NIXIE TAP
REV A MLADEN DINIC 2018

Nixie power supply

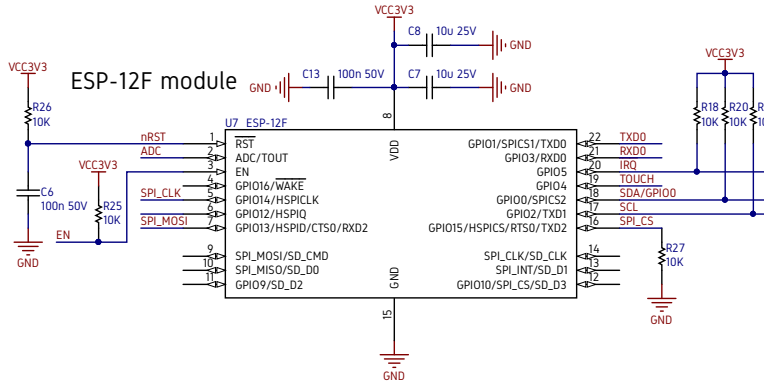
Currently the efficiency is ~80%, which is not enough.
IC and transformer must be replaced in REV B
